Road Safety Audit (RSA)

Mt. Hood Highway, Mile Post 47.0 – 54.3

Project No. 10261.0

FINAL Road Safety Audit REPORT

Figure 34

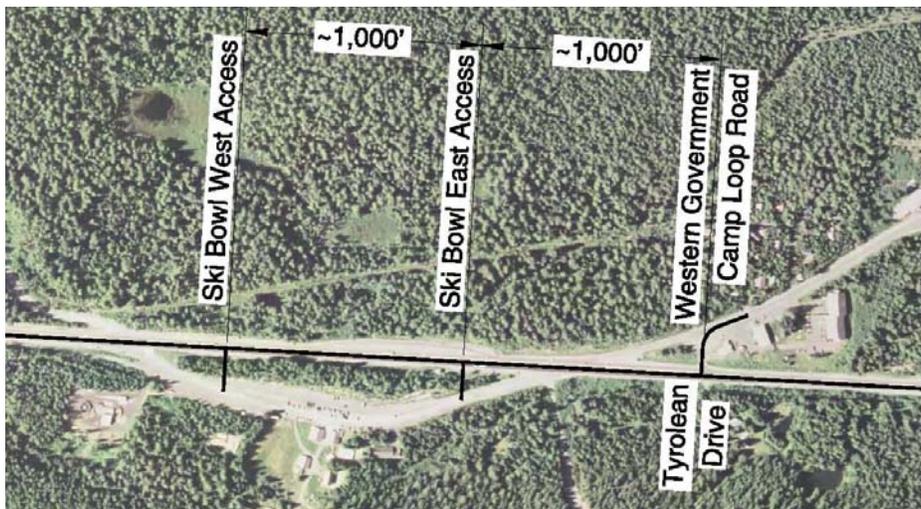
into Ski Bowl at this location (see Figure 32). The intersection sight distance, especially to the east, is limited due to the vertical crest curve to the east of this intersection (see Figure 33). There have been 9 crashes from 2000-2008 including 1 fatality. These crashes represent 3 fixed object, 3 rear-end, 1 turning, 1 side-swipe, and 1 head-on type crashes.

The Ski Bowl West Access should be realigned to the east by approximately 350 feet to the top of the crest curve (see Figure 34). This location would provide the optimum intersection sight distance and provide the opportunity to provide a standard westbound left-turn lane. The left and right turners can be separated at this realigned conventional T-intersection. Providing a 90-degree conventional T-intersection with appropriate deceleration distance for turning movements along the highway could address the majority of the crashes at this intersection. The side-street movements (especially the left-turns) will experience long delays and as traffic increases in future, this movement would become more challenging. A future consideration at this intersection could be a signal or a modern roundabout.
